# **Lime Down**

Solar Park

## **Change Application and Consultation Report (Change Application)**

**Document Reference: EXAM/9.40**

Title: Works Plans Comparison - Change 1

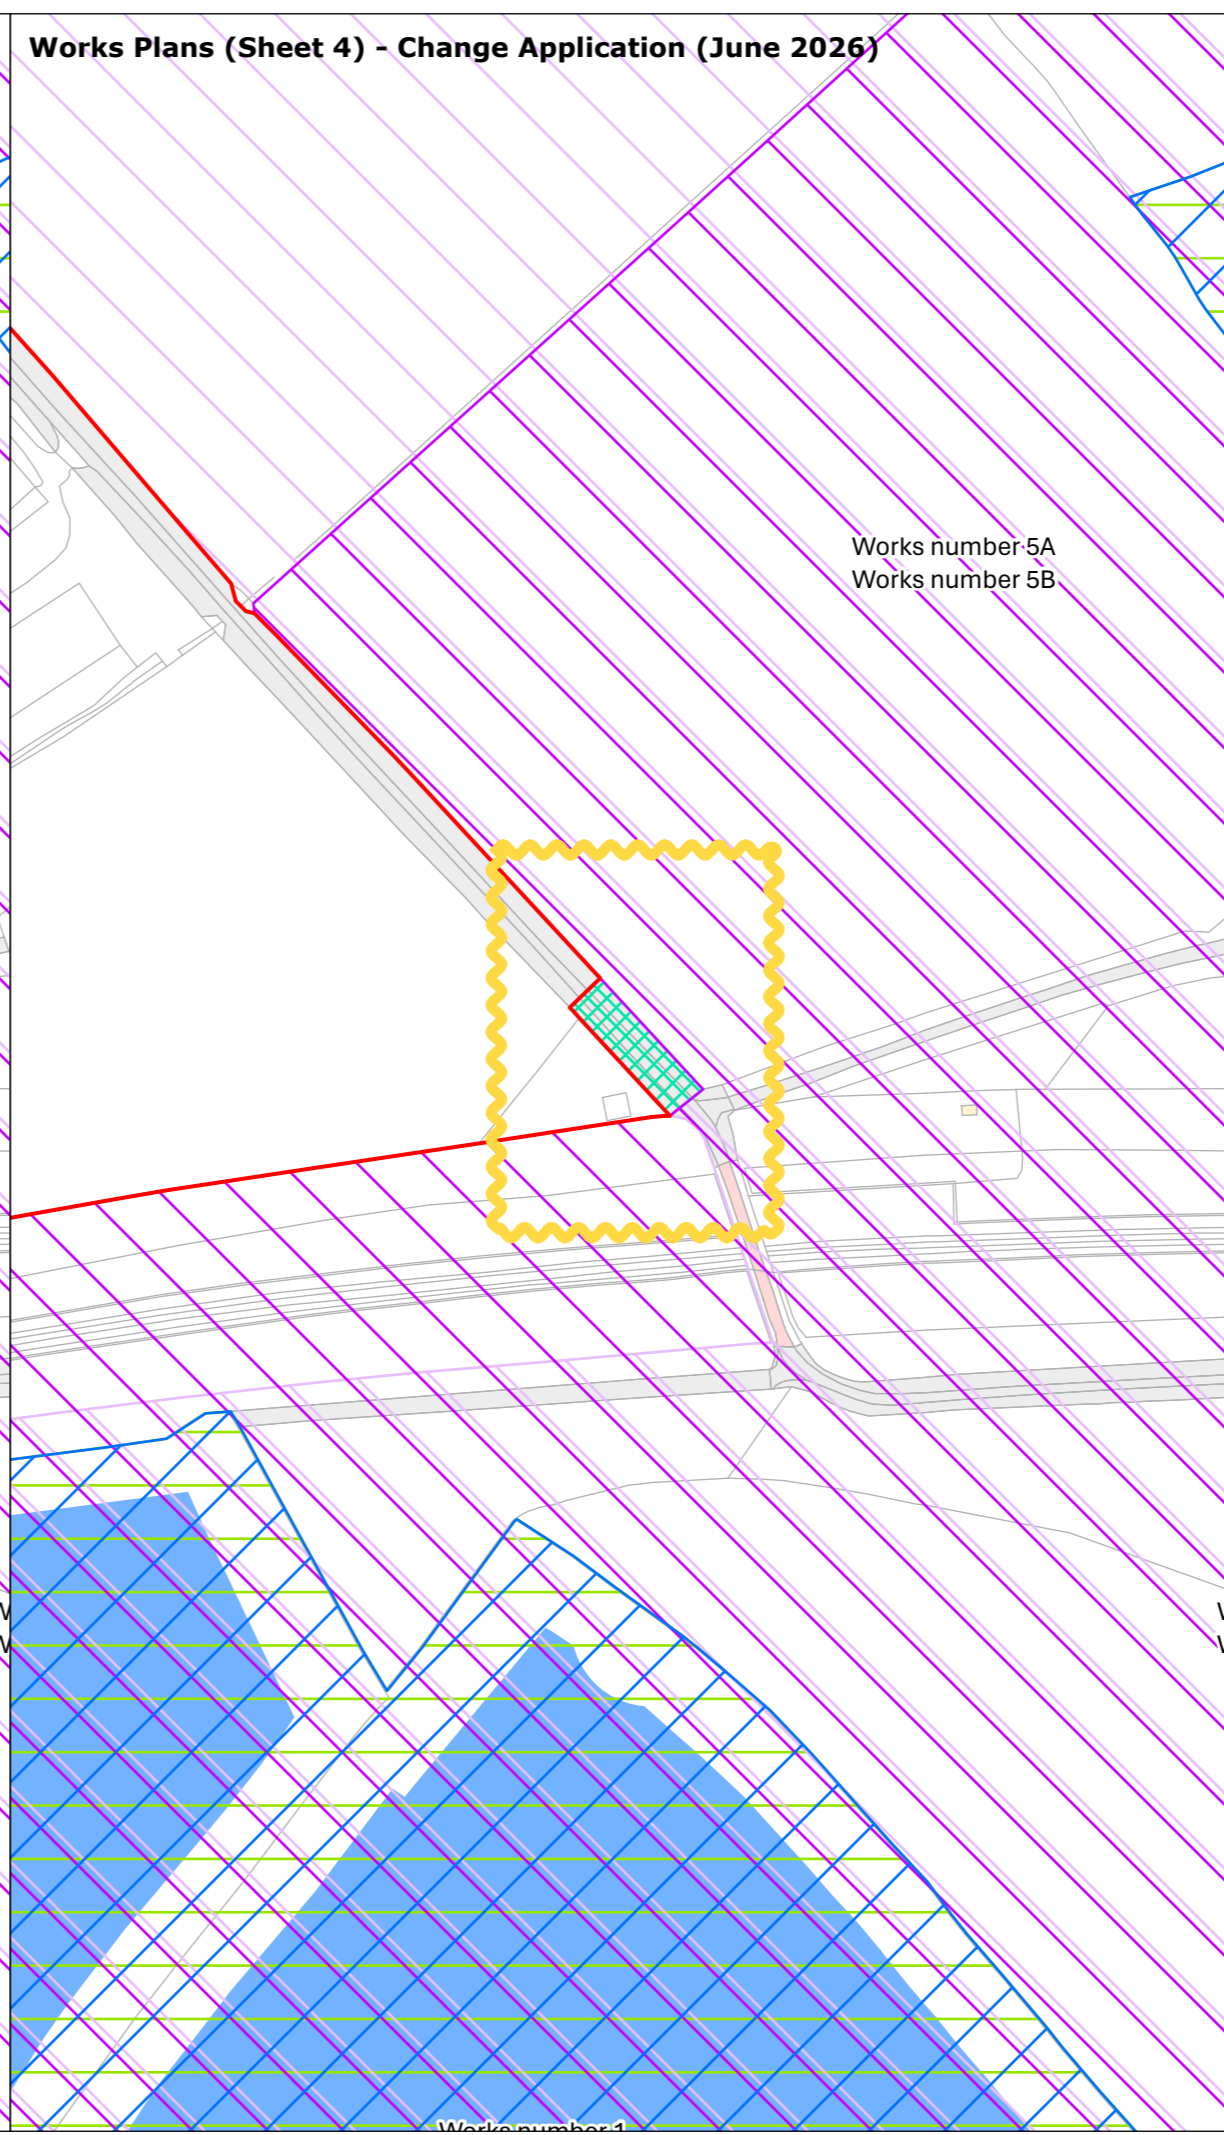
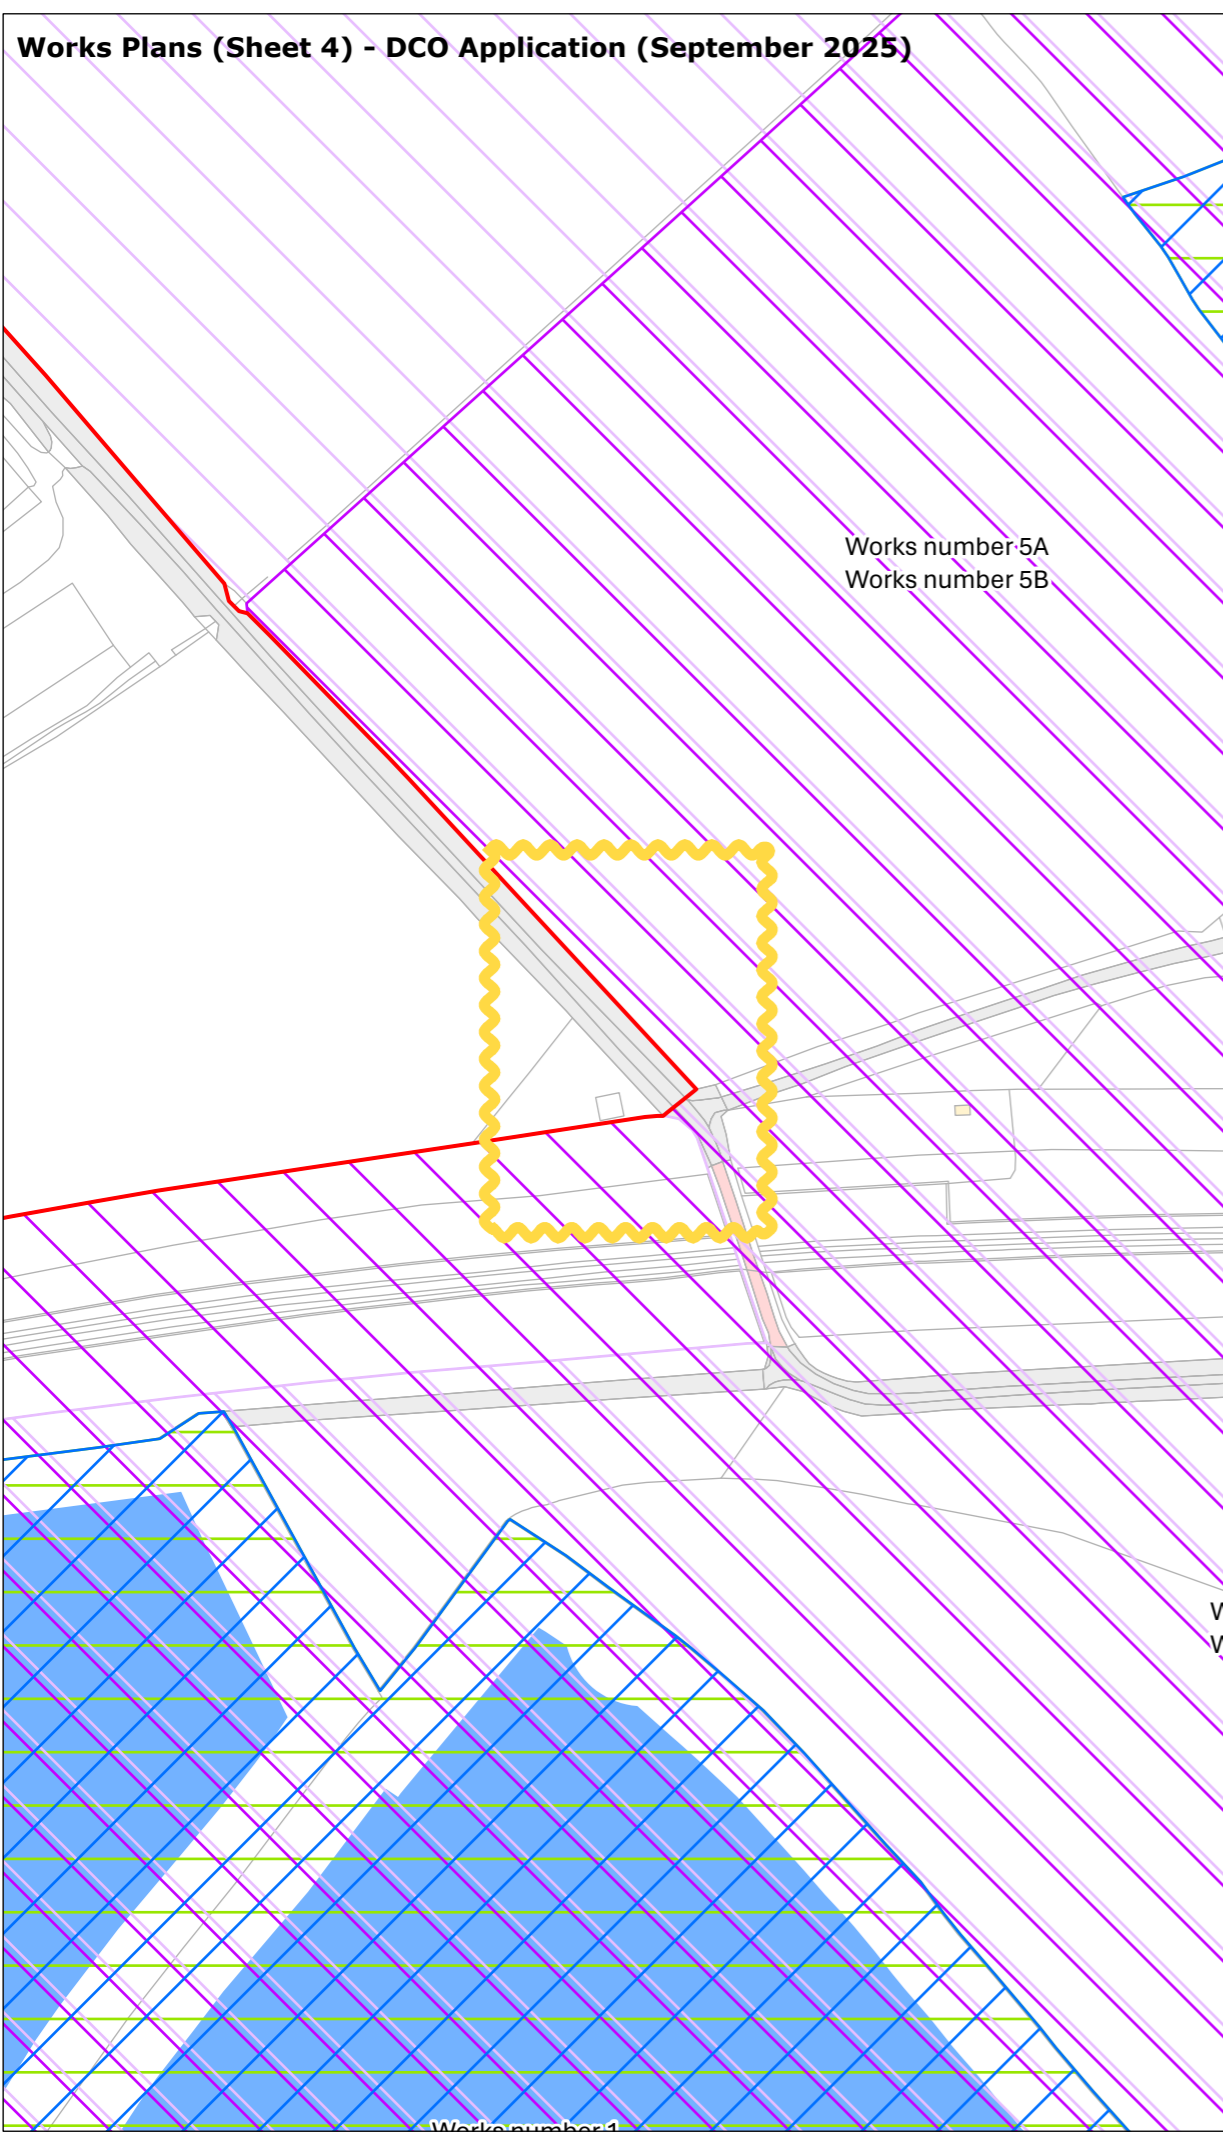
3.1.3 Change 1 comprises an extension to the Order Limits from the south western extent of the BESS emergency access (Access 21, as set out in Table 2 of the **Outline Construction Traffic Management Plan (CTMP) [REP3-108]**) at Lime Down D to the public highway named Hills Hayes Lane. A post-submission review by the Applicant of the Scheme accesses indicated that Access 21 did not adjoin the boundary of the public highway. This change will allow emergency Access 21 to tie into the public highway. The additional land will contain the bellmouth of emergency Access 21 which will comprise hardcore or gravel over a levelling layer of substrate. The additional land will be subject to Work Number 8b.

3.1.5 This land will be subject to compulsory acquisition of the rights, and is shown in blue on Sheet 4 of the **Land Plan [EN010168/APP/2.2] [Change Application]** forming Plot 04-036 which has increased in size from 83 to 525 square meters. This comprises land that forms part of the public highway where temporary possession powers are required. This ensures that any works to create the bellmouth junction can be carried out. The **Works Plan [EN010168/APP/2.3] [Change Application]** have also been updated to reflect Change 1.

Title: Works Plans Comparison - Change 2

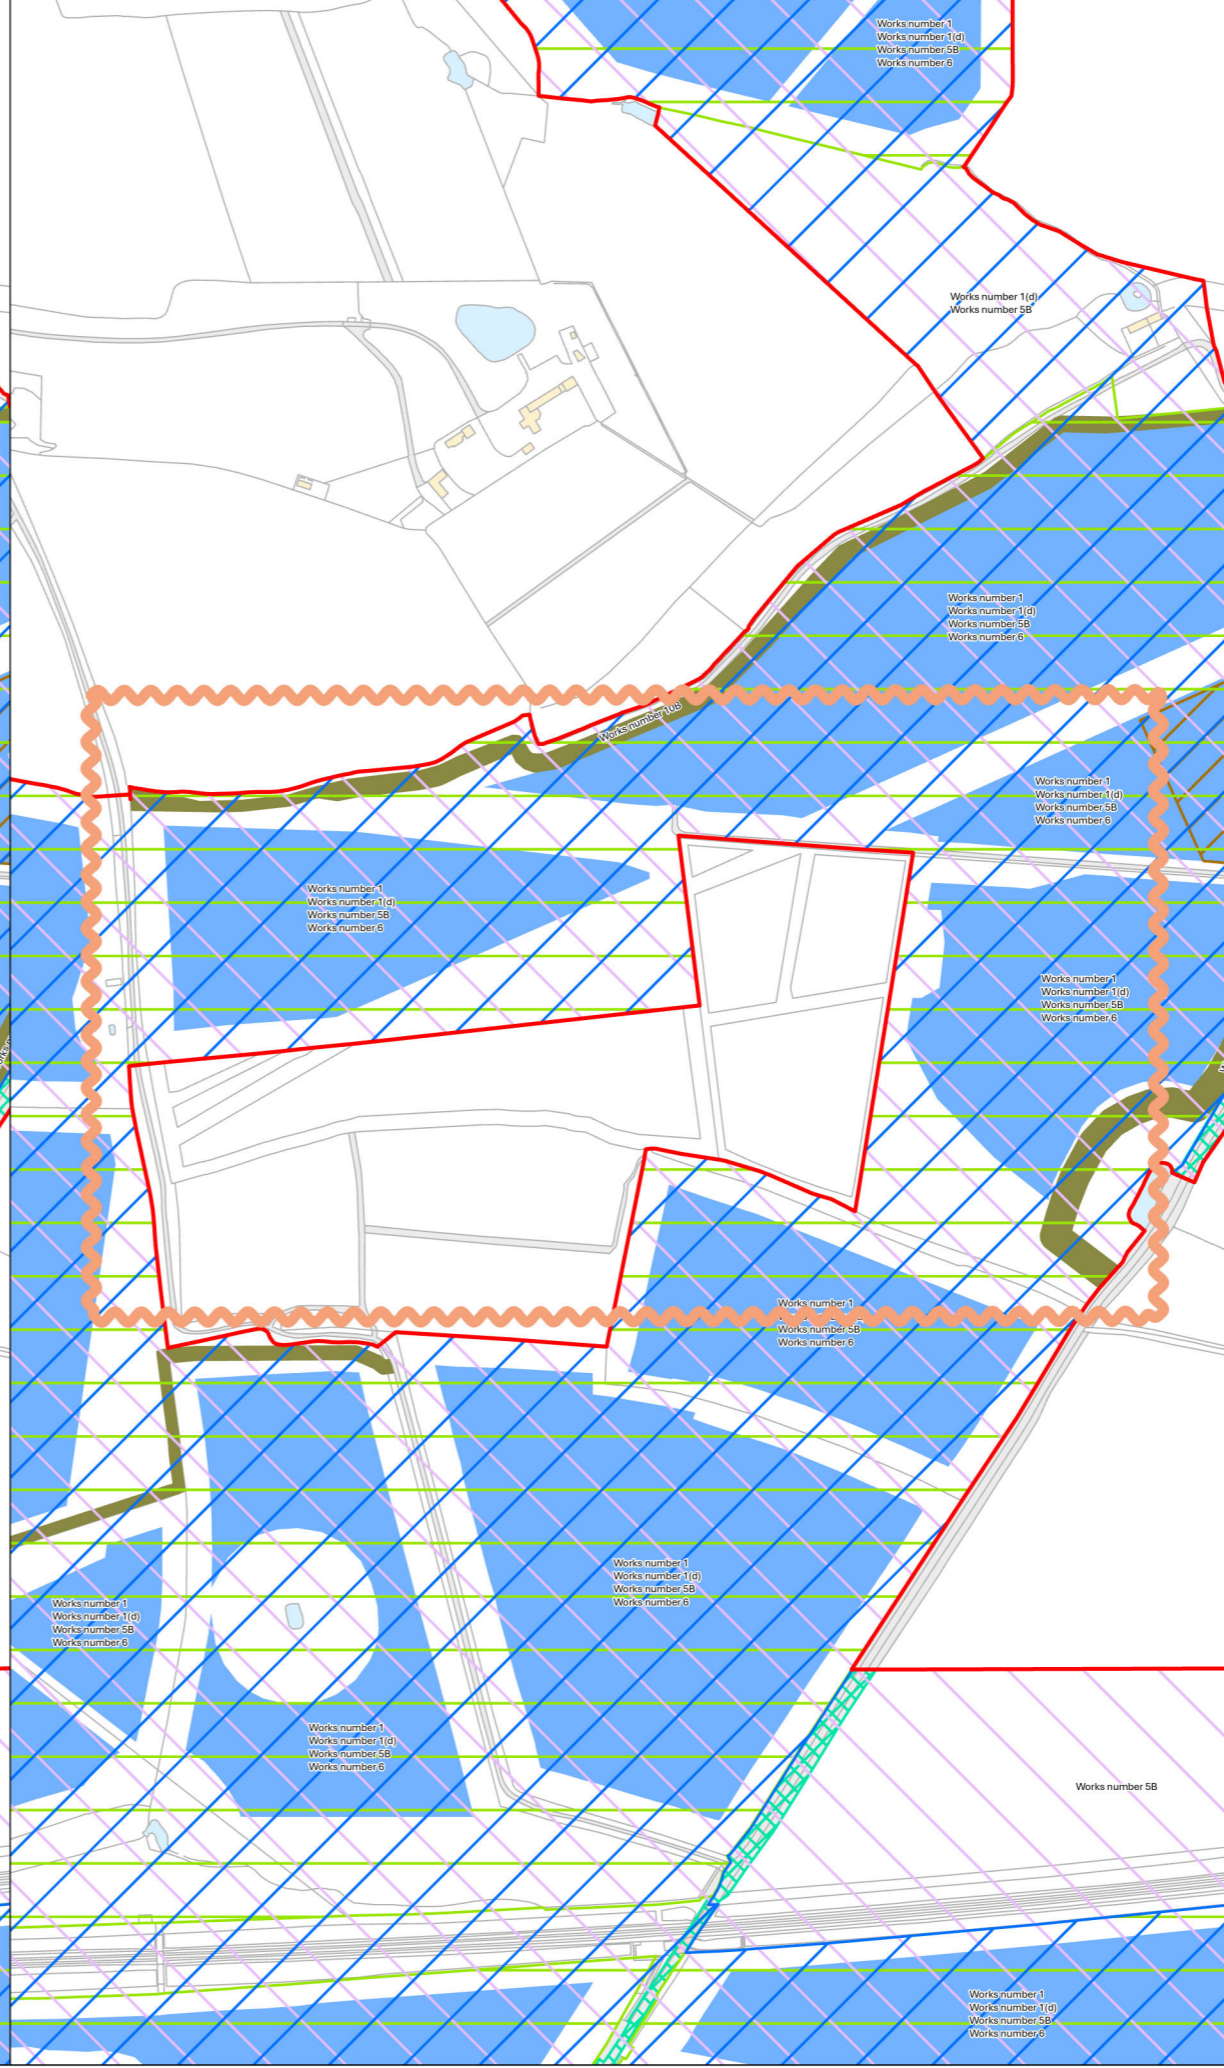
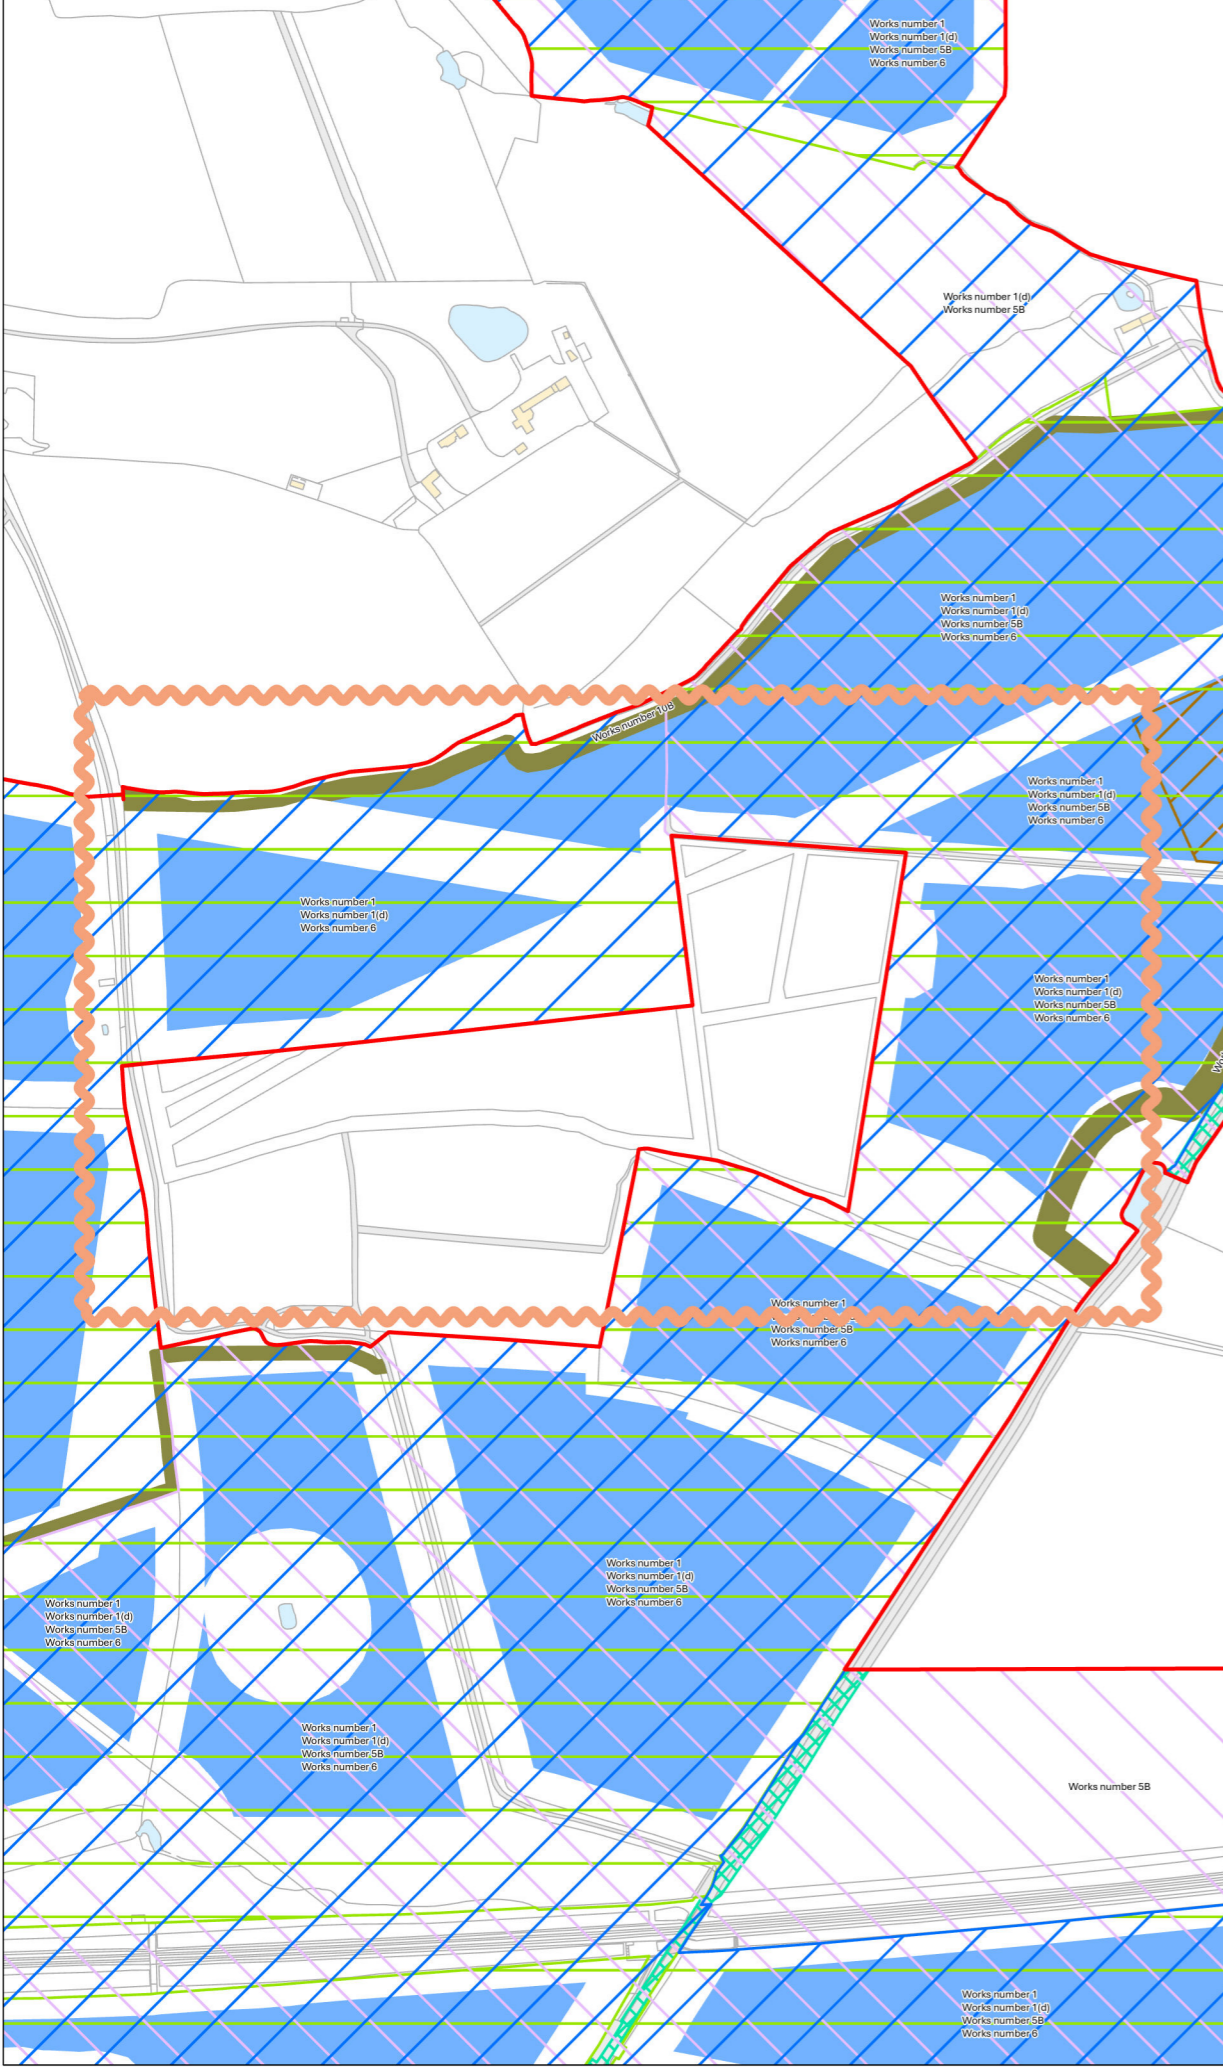
- 3.1.7 Change 2 comprises an update to the Works Plan to reflect the realignment of Solar PV Infrastructure within parts of Fields C21 and C23. This change reflects updated GIS data provided by Wiltshire Council that confirms the alignment of PRoW WT/SHER/18 as per the definitive map dated 5 March 2026, which has changed since the DCO Application was submitted.
- 3.1.8 There will be no change to the extent of Work Number 1, and the realigned Solar PV Infrastructure will retain a 15m offset from the PRoW.
- 3.1.9 The **Works Plan [EN010168/APP/2.3] [Change Application]** and **ES Volume 2, Figure 3-4 Landscape and Ecology Mitigation Plan [EN010168/APP/6.2] [Change Application]** have been updated to reflect Change 2.
